PROPOSAL REQUEST

Project Name:	Haverhill Consentino Middle School	PR No.	11
Architect's Project No.	21-0818		
Owner:	City of Haverhill 4 Summer Street Haverhill, MA 01830	Architect:	DORE + WHITTIER 260 Merrimac St, Bldg 7, Newburyport, MA 01950
To:	Brait Builders Corporation 57 Rockwood Road Marshfield, MA 02050	Contract Date	4/1/2024
		Issue Date:	8/6/2024
Attention:	TJ Dahill	Subject:	Area D Roof Drains

JD-31, JD-32, JD-33

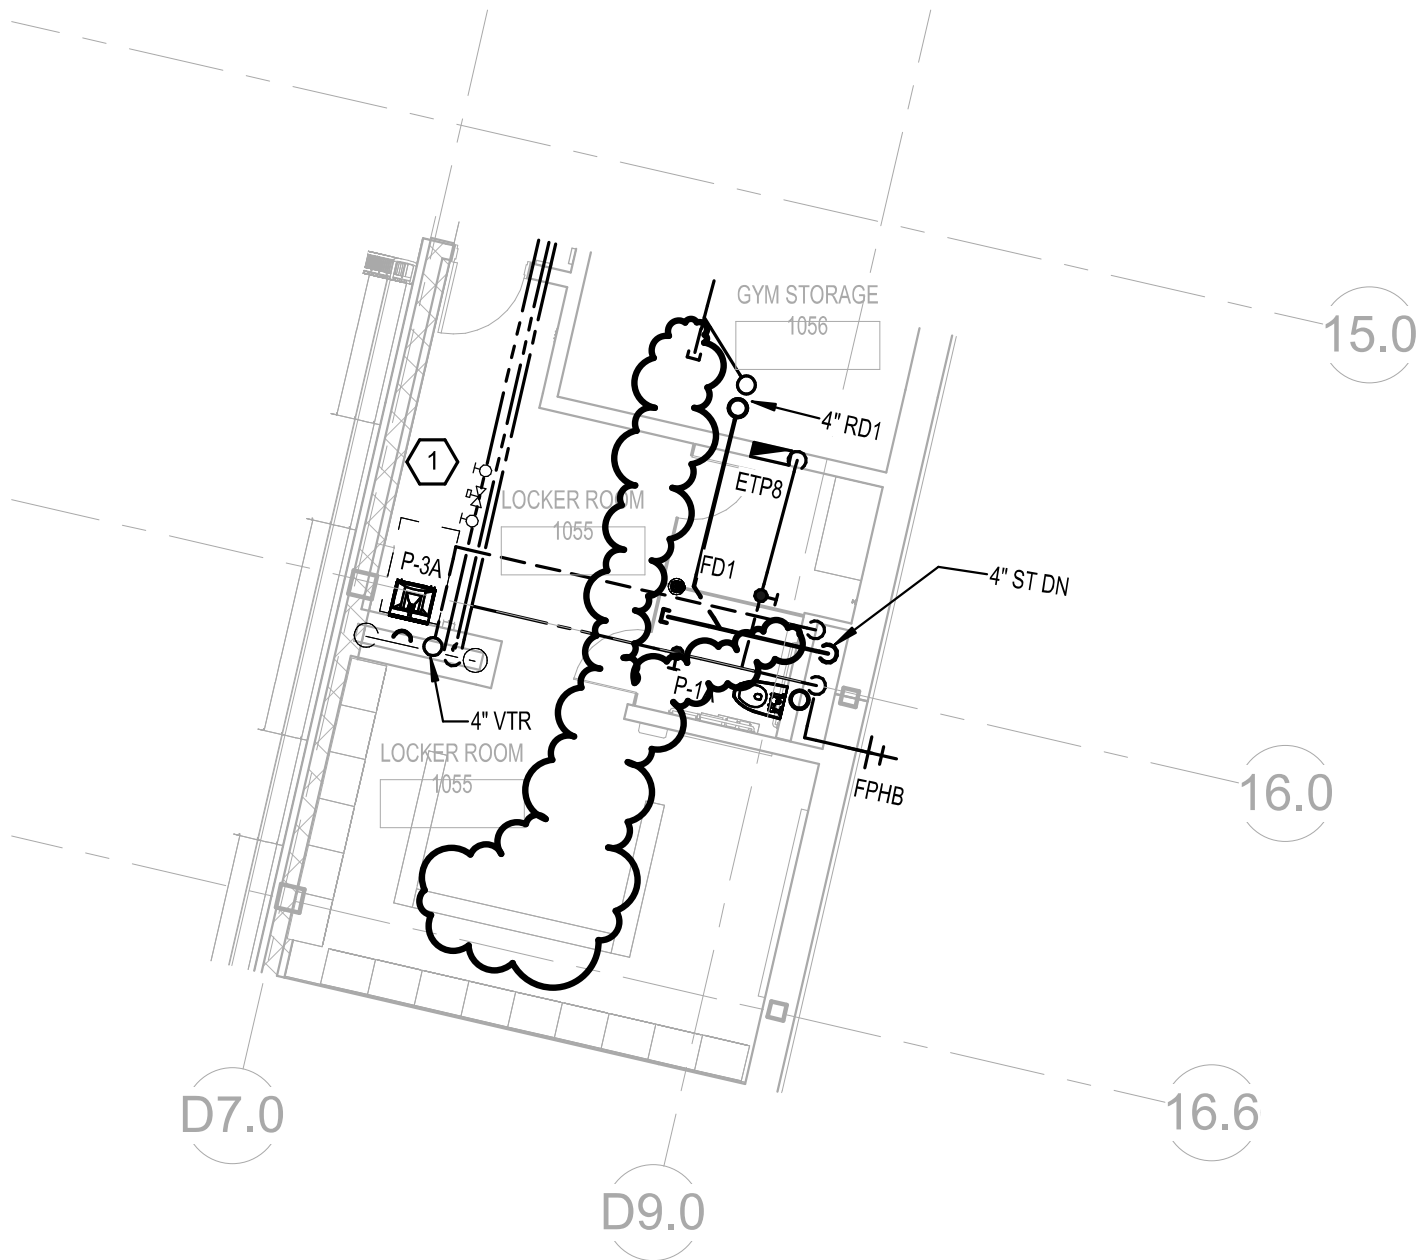
At Sheet A3.14, Roof Plan – Area D, revise location of roof drain along grid 8.0 and between grids D1.0 and D2.0, as shown on attached sketch **JD-31**. Revise tapered insulation accordingly.

JD-32

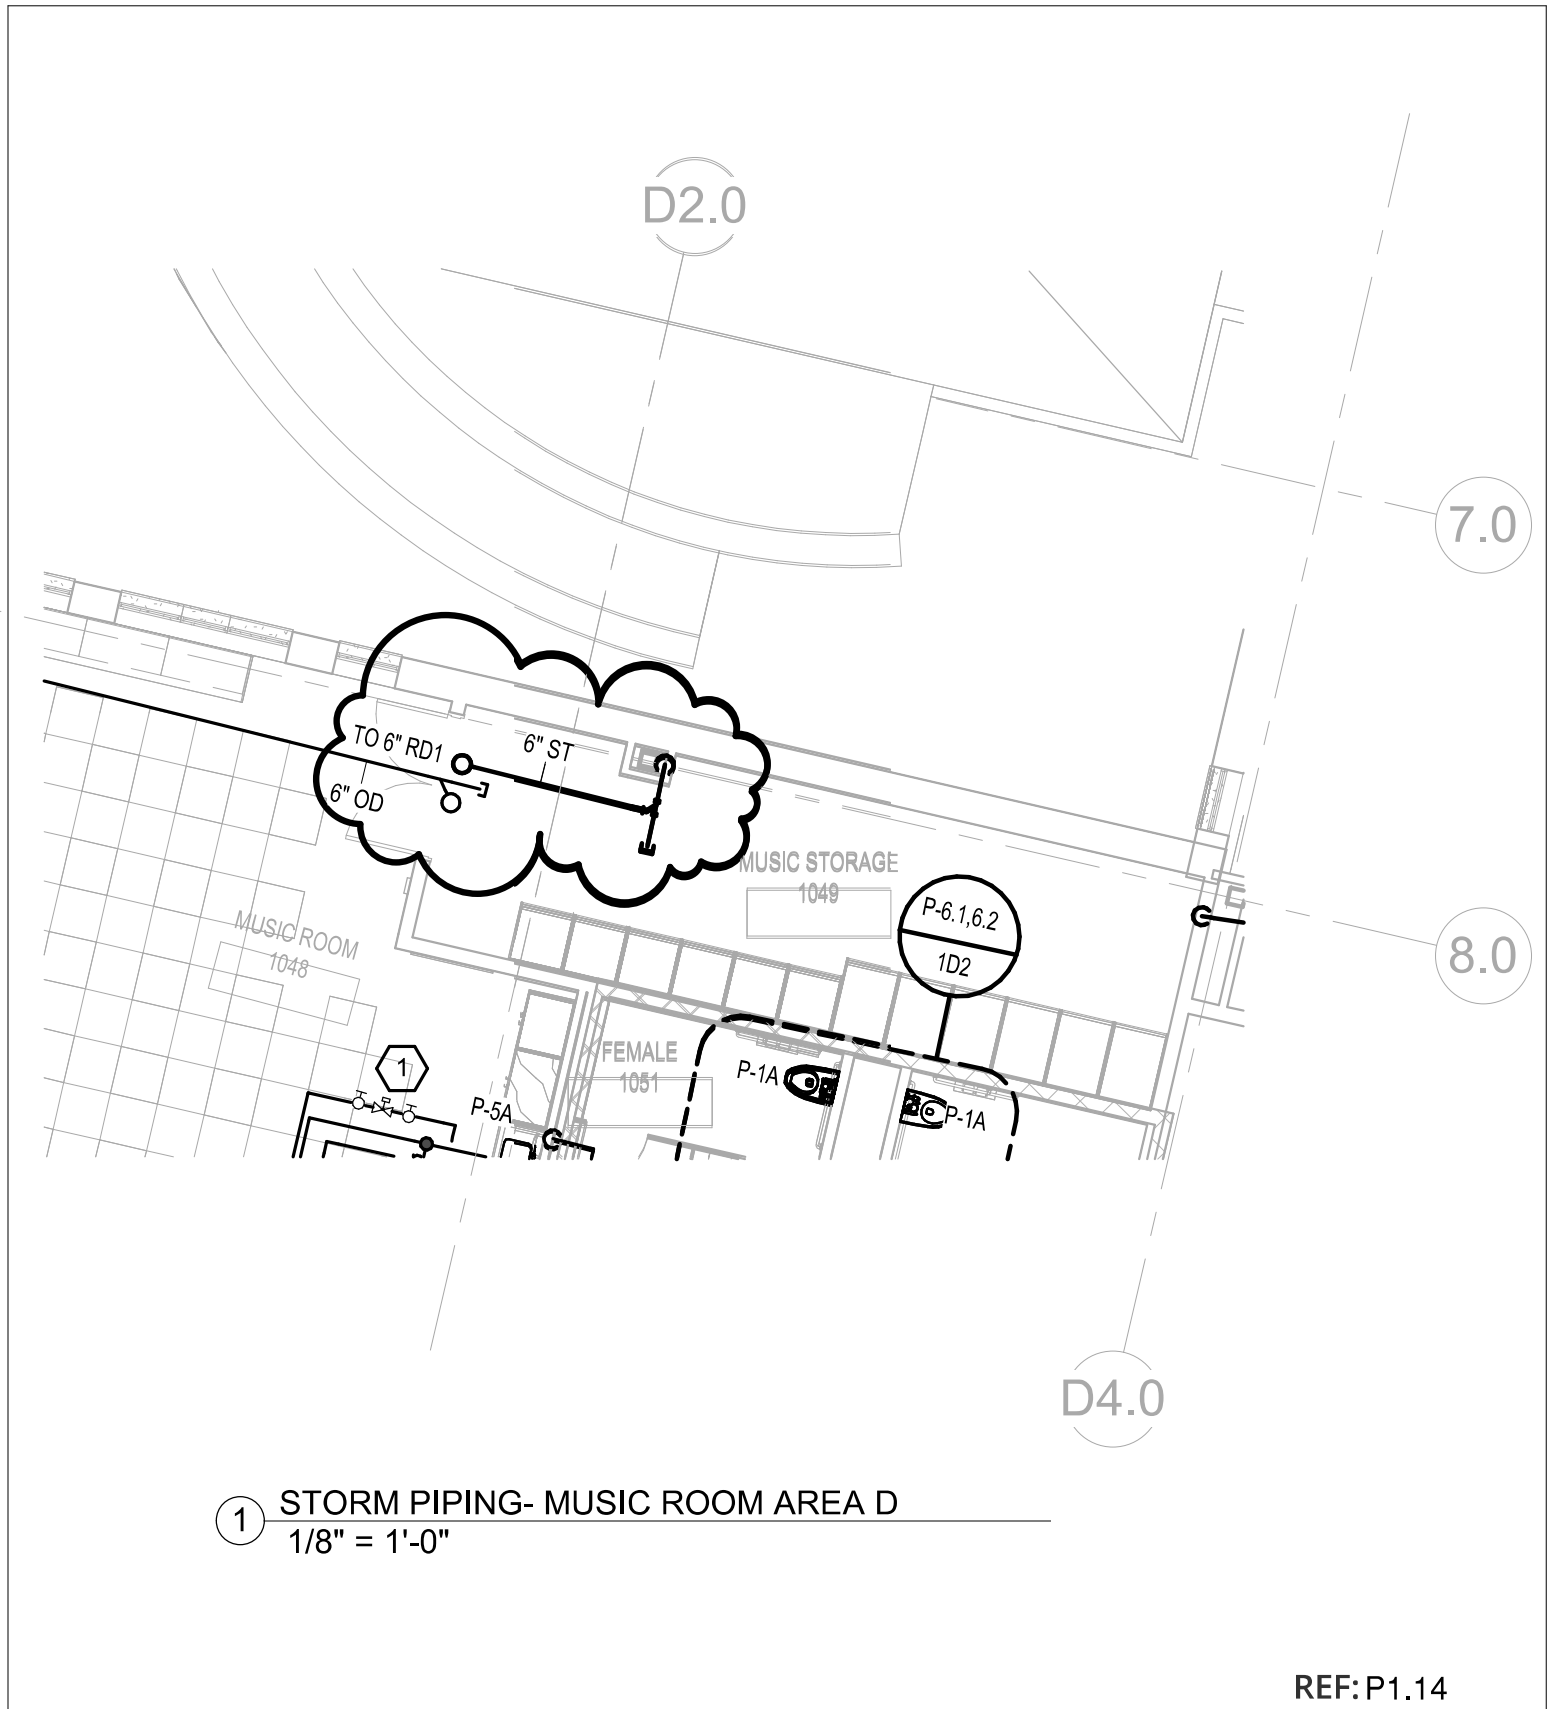
At Sheet P4.13 Plumbing Overall Roof Plan, delete 4" RD1 and associated piping from Gym storage to proposed drain, as shown on Sheet P1.14 at grid 17.0 (shown as grid 16.6 on Plumbing drawings) to match architectural roof plan A3.14. Refer to attached sketch **JD-32**. Make similar revision to P2.14.
